UNITED STATES
NUCLEAR REGULATORY COMMISSION
WASHINGTON, D. C. 20555

SUBJECT: MINUTES OF CRGR MEETING NUMBER 79

Enclosure 2 to the Minutes of CRGR Meeting No. 79
Proposed Draft of Revision 2 to Regulatory Guide 1.99
"Radiation Damage to Reactor Vessel Materials"

DRAFT REGULATORY GUIDE 1.99, REVISION 2
RADIATION DAMAGE TO REACTOR VESSEL MATERIALS

TABLE 1. SUMMARY OF THE CHANGES IN PRESSURE-TEMPERATURE LIMITS EXPECTED TO RESULT FROM A CHANGE FROM REVISION 1 TO REVISION 2 OF REGULATORY GUIDE 1.99

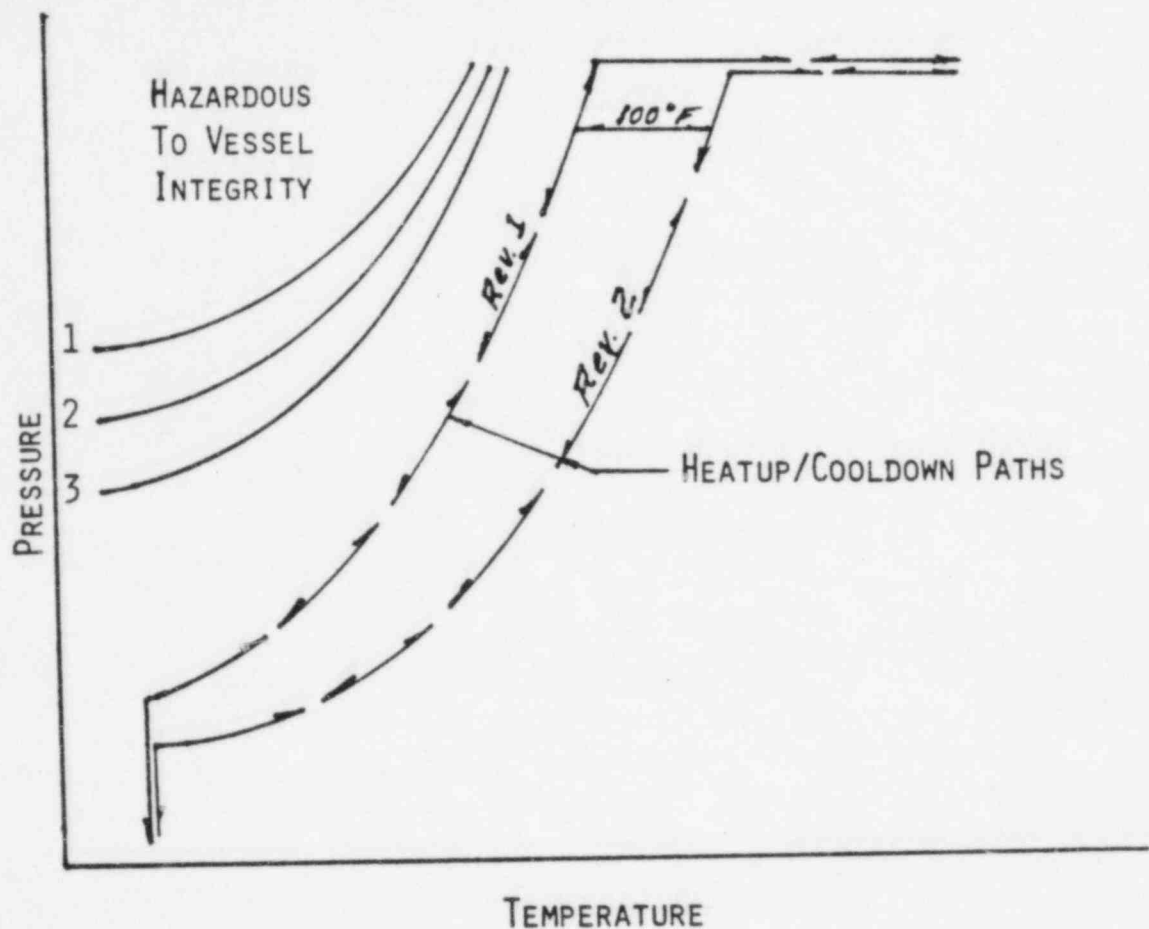
CRGR was advised that the proposed RG 1.99 Revisions would bring about greater restrictions on the pressure-temperature (PT) operating band for both the BWR and PWR plants. The BWR plants would, for example, be faced with difficulties in carrying out certain post-refueling hydrotest operations required by the ASME code. Although the full BWR implications were not available to CRGR or the staff, CRGR was advised that some of the older BWR plants may be forced into providing additional equipment for heatup, use of unusual system configurations or the use of the RHR pumps for heating, etc. so as to minimize the

CRGR concluded that there was insufficient information provided in the RG package to permit a more complete exploration and understanding of this matter. Of particular importance to the CRGR were the implications to the PTS issue. CRGR commented that this new information should have been better integrated with the recent PTS rule and the ongoing PTS work. CRGR recommends that the EDO request NRR and RES to give a priority effort to the integration of these separate actions to the extent required by the new information at hand. ELD should also work closely with NRR and RES on this matter.
